FINAL ORDER

The Special Standards Request Form you submitted for owner: Michael Keiser, Start Card numbers 1039276, 1039289, 1039322, 1039336, 1039373 and 1039390, is hereby approved for the following: You may remove your drilling machine from this well construction site prior to completion of the wells. This is due to the fact that you are awaiting sieved analysis and well screen construction and will complete the wells after receiving the material. It is our understanding from your request that you have installed 6 inch steel casings within a 10 inch borehole, for each well, to a depth of 18 feet and sealed the annular space to the surface with bentonite chips. A condition of this Special Standards Request is that the drilling machine return to the site and the wells be completed within six weeks from the date of this letter. A copy of your Special Standards Request Form is enclosed.

REQUEST FOR WRITTEN APPROVAL TO USE CONSTRUCTION METHODS NOT INCLUDED IN OREGON ADMINISTRATIVE RULES 690-200 THROUGH 690-240

- (7) Diagram showing the pertinent features of the proposed well design and construction: (attach additional pages if needed)

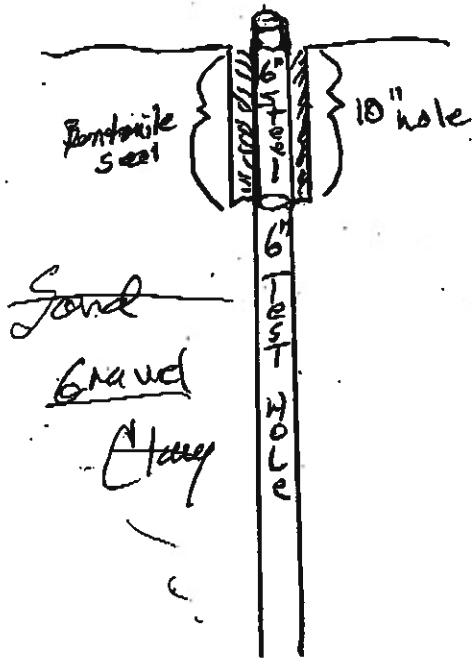
(6) The proposed construction methods that the bonded well constructor believes will be adequate for this well: (attach additional pages if needed)
6" steel installed in 10" hole down to 18' and sealed
to surface with bentonite. 6" steel will be removed
and 12 1/2 hole drilled to depth to accommodate 8" screen
+ casing.

6" steel will be removed +
 Hole will be opened to
 accommodate larger casing
 and screen
